TRANSFER TURRET

No. 217.2

UPGRADE KIT
 PMC-1002

Gripper Module Retrofit Assembly

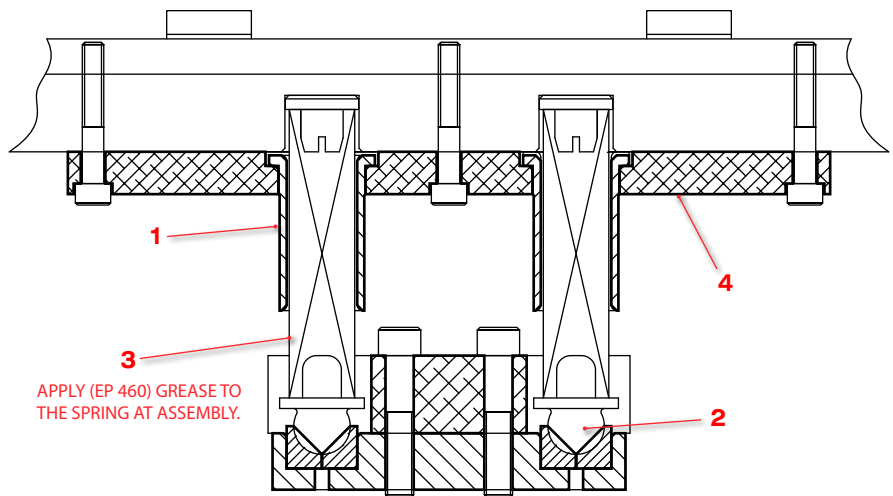
After successfully field testing the Hardened Sleeves and Short Spring Post, Paper Machinery Corporation is pleased to offer an Upgrade Kit (228-862) for the Transfer Turret Gripper Modules. This upgrade will extend the service life of the Spring and Sleeve.

Part	Description	Qty.
[1] 110-732	Spring Sleeve	10
[2] 227-305	Spring Post	10
[3] SP-10018	5/8 OD x .090 x 3 MD CMPR Spring	10
[4] 317-630	Turret Adaptor Plate	5
